Date 08/9/22

Addendum # 2 to Bid 002592 Ventilated Caging Rack System

LEVEL THREE FLOOR PLAN

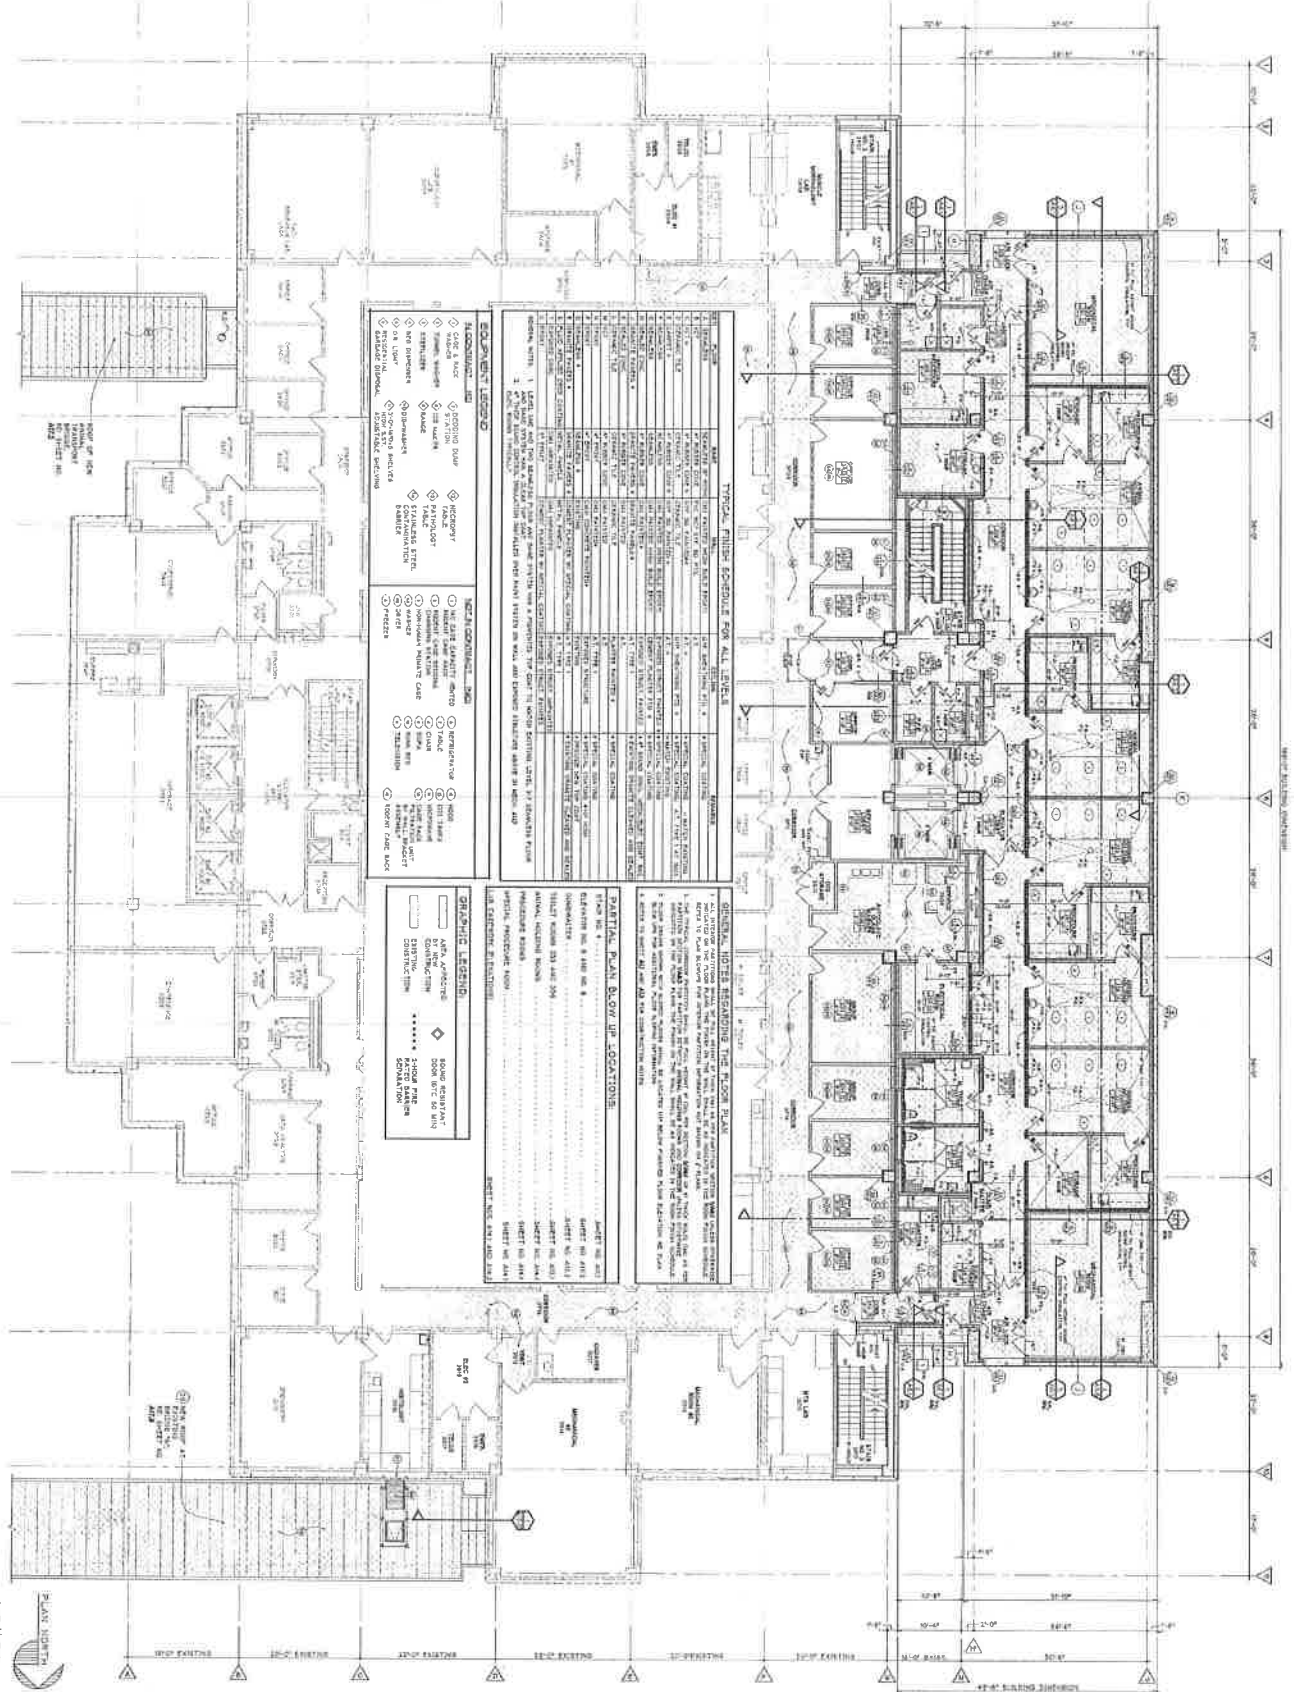
Q. Are there room drawings or average dimensions of rooms available?

A. See attached floor plan for reference.

DETAIL - IRIS DAMPER, TYPICAL

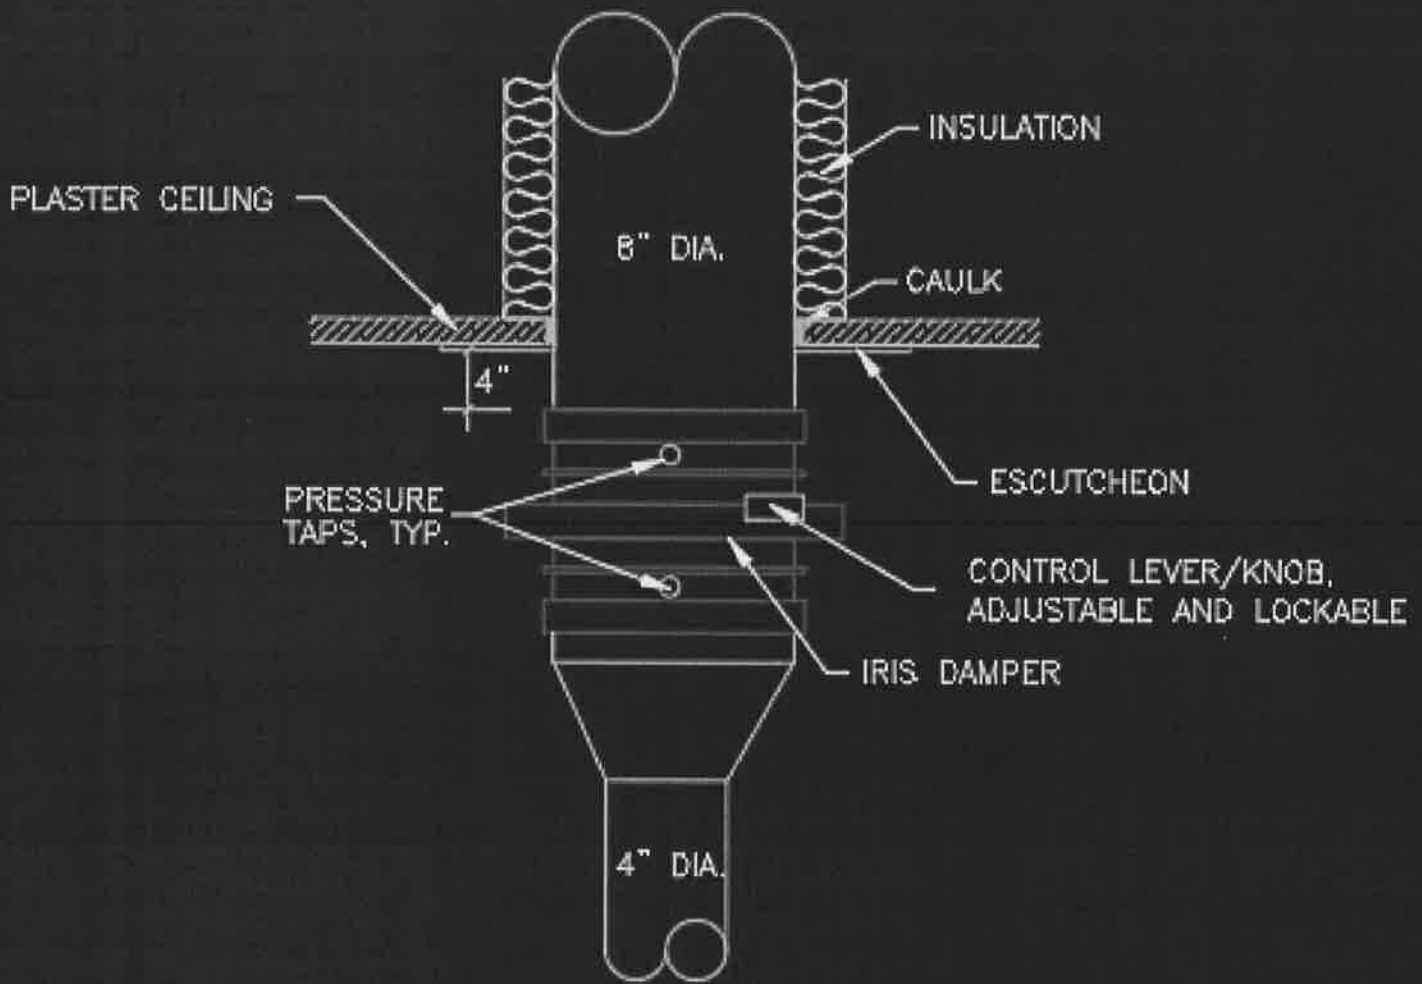
Q. Is there any connection to building exhaust required? - If so, please describe requirements

A. Yes, they will need to supply and install a 8" to 4" transition exhaust duct from existing Irish Damper from ceiling to Animal Rack. Please see attached detail for reference.
